HISTORIC AND DESIGN REVIEW COMMISSION

March 01, 2017

HDRC CASE NO: 2016-533
ADDRESS: 608 DAWSON ST
610 DAWSON ST
LEGAL DESCRIPTION: NCB 569 (DAWSON PLACE), BLOCK 17 LOT 19
NCB 569 (DAWSON PLACE), BLOCK 17 LOT 20
ZONING: R-3,H
CITY COUNCIL DIST.: 2
DISTRICT: Dignowity Hill Historic District
APPLICANT: Carlos Rodriguez/Brightstar Development, LLC
OWNER: Brightstar Development, LLC
TYPE OF WORK: Revisions to previously approval for new construction
REQUEST:

The applicant is requesting an amendment to a previous Certificate of Appropriateness issued by the Historic and Design Review Commission. The amendments include the following:

DOORS AND
WINDOWS

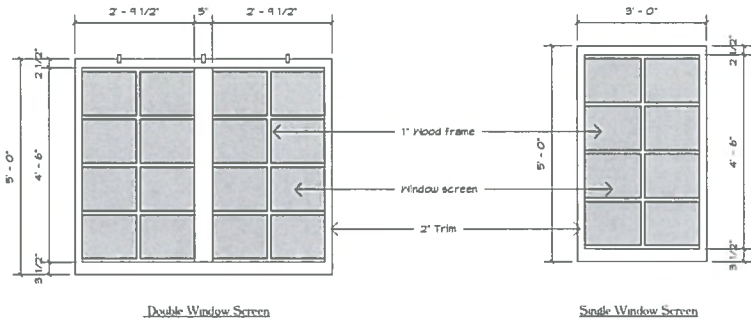
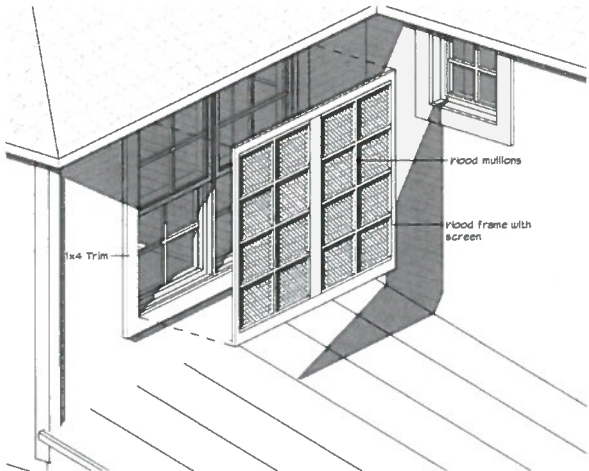
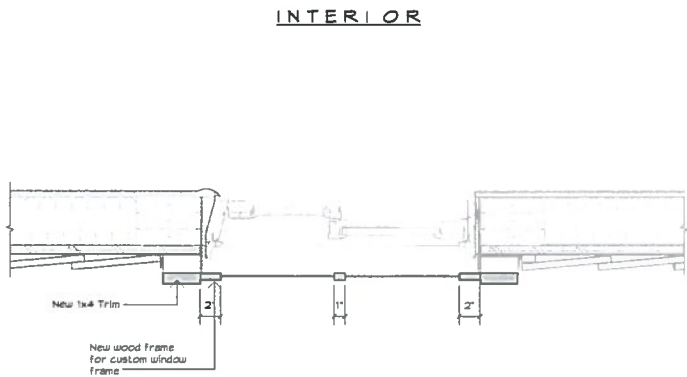
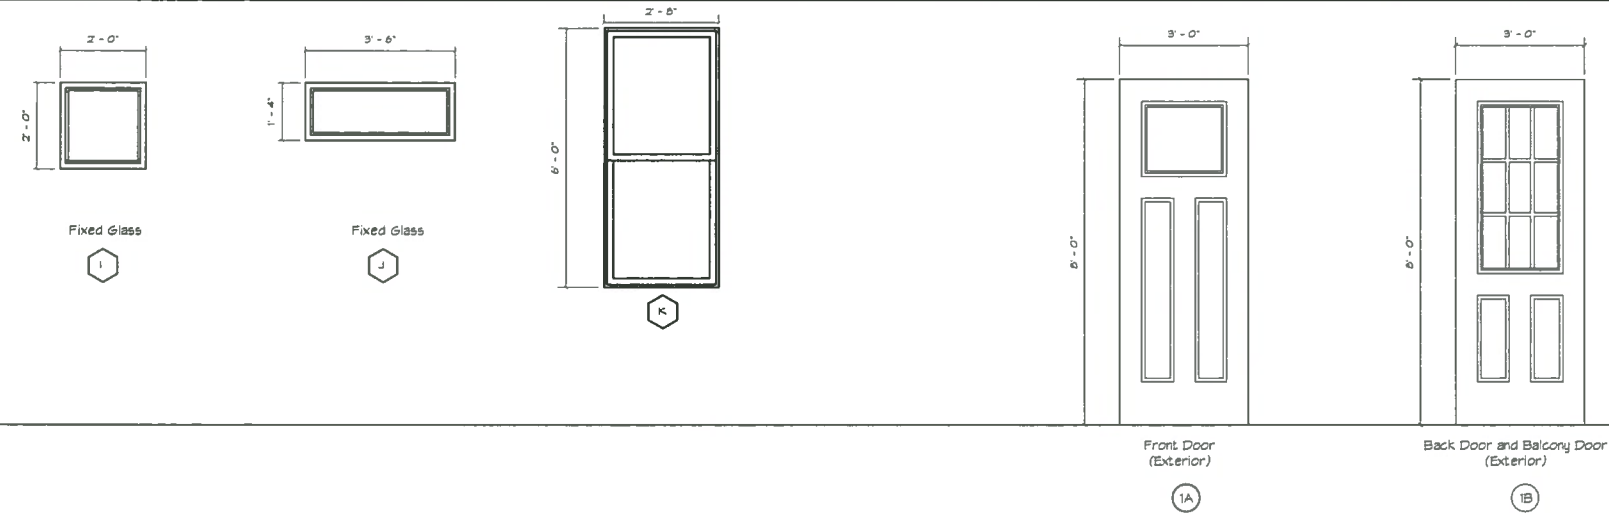
- g. **SCREENS** – Eighteen (18) of the proposed aluminum clad windows that face the street will be covered with wood 4-over-4 screens. According to the Guidelines for New Construction 3.A.i, use materials that complement the materials and architectural details typically found in the district. Staff finds the wood window screens are consistent with historic structures found in Dignowity Hill Historic District and that the installation of the window screens are consistent with the Guidelines as they will be inset within the window trim.

Staff does not recommend wood screens as a solution to conceal the unapproved windows. If the HDRC approves the currently-requested windows based on the circumstances presented, then staff recommends approval of the proposed wood screens as submitted.
